Access Compliance Report Public Rights-of-Way (Curb Ramps)

Main Street: SIENNA_PKWY		Cross Street: WINDMILL_AVE		Location:	N
ADA ID: RPRK211109115544	Ramp Type: Type 1 - Perpendicular	Initial Pass/Fail: Fail	Overall Compliance: No	Severity Score:	45

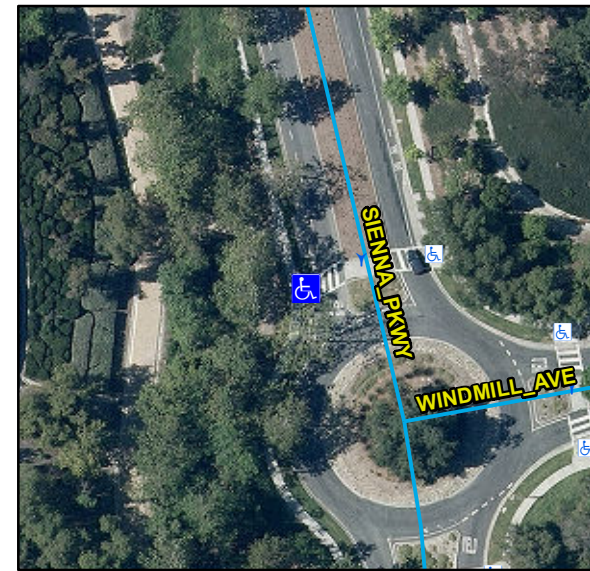
R304.2.2, R204.3, R304.5.3, STD 1115

Remove & Replace Entire Ramp.
